Re: Motiv Technical Bulletin for the following recall notices

- **24V547 (CAN loopback)**
- **24V603 (CAN Loopback / SB)**
- **2024-422 (CAN loopback / TC)**

DCFC Loopback harness Motiv P/N 840-110346-001 REV A

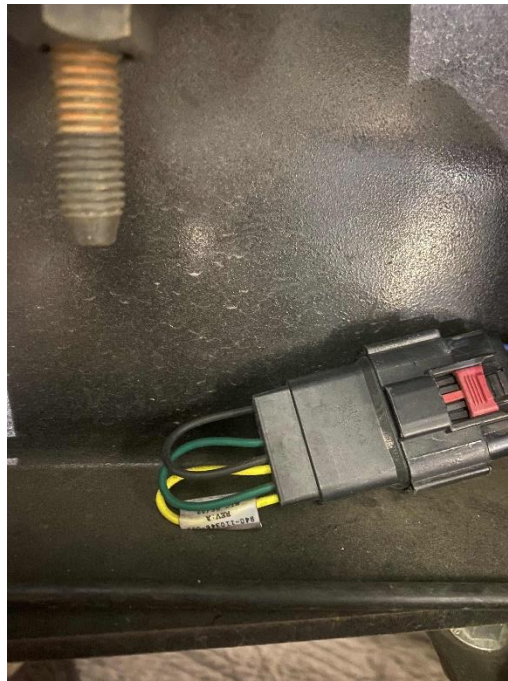
Inspect all potentially affected vehicles and correct any erroneous retention and replace any CAN wiring showing signs of chafing as per picture below.

1. Locate CAN loopback wiring on the driver side frame rail aft of rear leaf spring mount.

2. Wrap exposed wiring with fabric tape (Motiv P/N 110-112172-001 REV A / Mfg. P/N TESA 51036) to prevent wire damage.
3. Securely retain loopback harness to frame rail crossmember above rear battery pack.
